TECHNICAL INSTRUCTION

T.I. No. 106/T59

T59 'Kestrel' Elevator Push Rod in Fin

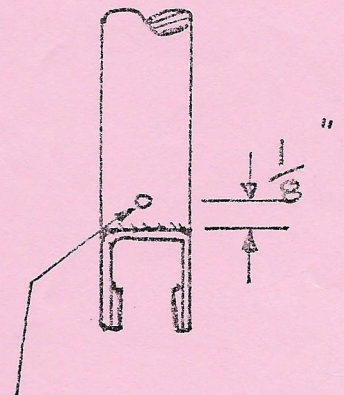
JUSTIFICATION An inspection on a Kestrel revealed internal corrosion on the push rod of the elevator, sufficiently advanced to corrode through the rod wall, due to water ingress from the top inspection hole.

The Push Rod must be removed for examination. Bottom access can only be gained through the removal of the wheel well fairing. If possible inspect to check wall thickness at the bottom. See Fig. If facilities exist for ultrasonic inspection or x-ray to ensure no internal corrosion then the rod can be refitted. If structural integrity cannot be confirmed then the rod must be replaced.

1/16" dia inspection hole can be drilled and left open on refit if no corrosion found.
